# UNITED STATES PATENT AND TRADEMARK OFFICE

APPLICATION NO.	FILING DATE	FIRST NAMED INVENTOR	ATTORNEY DOCKET NO.	CONFIRMATION NO.
10/584,161	03/29/2007	Juergen Eberle	2003P01969WOUS	5081

<b>Office Action Summary</b>	<b>Application No.</b> 10/584,161	<b>Applicant(s)</b> EBERLE ET AL.	
	<b>Examiner</b> JONATHAN KOAGEL	<b>Art Unit</b> 3744

## **DETAILED ACTION**

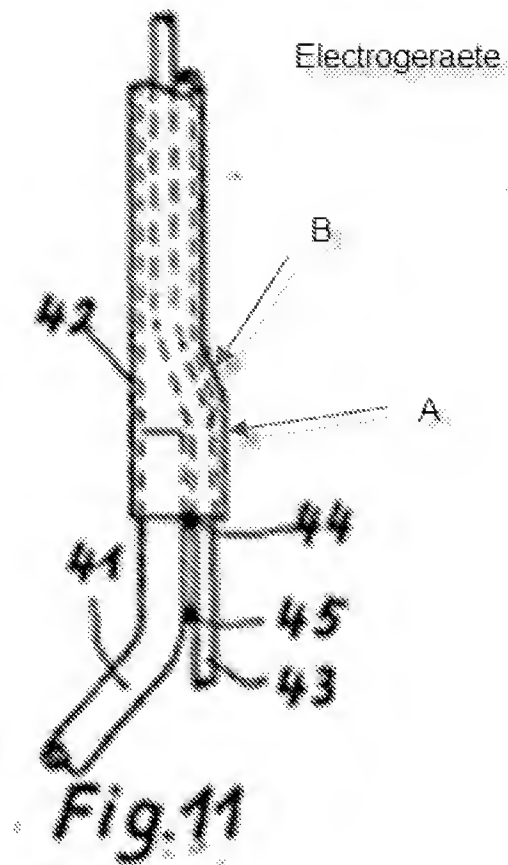
Regarding claim 7, Electrogeraete teaches in fig. 11, a refrigerating unit comprising a suction tube 41, 42 and a throttling tube 43 which runs at least over a part of its length inside the suction tube 41, 42 and is guided out from the suction tube 41, 42

to form a first outlet location 44 wherein the throttling tube 43 and the suction tube 41, 42 are joined to one another at a second location 45 of the suction tube 41, 42 at which outer surfaces of the throttling tube 43 and the suction tube 41, 42 are in contact, wherein the outer surfaces of the throttling tube 43 and the suction tube 41, 42 are joined to one another at the second location 45 by welding (pg. 4 paragraph 7).

Regarding claim 8, Electrogeraete teaches in fig. 11 that the first and second locations, 44 and 45 are spaced apart at a distance. Electrogeraete fails to explicitly teach where the second location is spaced apart from the first location at a range of 5mm to 20mm.

Regarding claim 9, Electrogeraete further teaches in fig. 11 wherein the second location 45 is located downstream from the outlet location 44 with reference to the refrigerant flowing in the suction tube 41, 42.

Regarding claim 10, Electrogeraete further teaches in fig. 11, wherein the outlet location 44 is provided at a connecting tube A (labeled by examiner) on which both the suction tube 41, 42 and the throttling tube 43 are fixed downstream in a liquid and gastight manner (pg. 4 paragraph 7). Electrogeraete discloses that the tubes are brazed and welded at the locations 44 and 42. Therefore, the tubes are fixed in a liquid and gastight manner.

Regarding claim 11, Electrogeraete further teaches in fig. 11, wherein the suction tube 41, 42 has an expansion B (labeled by examiner) for the throttling tube 43 in the area of the outlet location 44.

Regarding claim 12, Electrogeraete further teaches in fig. 11, a method for joining a suction tube of a refrigerating unit to a throttling tube comprising the following acts, guiding the throttling tube 43 out from the inside of the suction at an outlet location 44 of the suction tube 41, 42, joining the suction tube 41, 42 and the throttling tube 43 at the outlet location, bringing in contact an outer surface of a portion of the throttling tube 43 located outside the suction tube 41, 42 with an outer surface of the suction tube 41, 42 at a second location 45 of the suction tube 41, 42, joining the suction tube 41, 42 and the throttling tube 43 at the second location 45, joining the outer surfaces of the suction tube 41, 42 and the throttling tube 43 to one another at the second location 45 by welding (pg. 4 paragraph 7). Regarding the joining of the suction tube and the throttling tube at the outlet location by soldering, Electrogeraete teaches an equivalent technique of brazing which allows both the tubes to become joined together by the use of a filler metal which melts and creates a sealed joint. Both brazing and soldering use a filler metal that melts and creates a sealed joint without the melting of the surfaces that are being joined. Electrogeraete fails to explicitly teach the use of ultra sound welding.
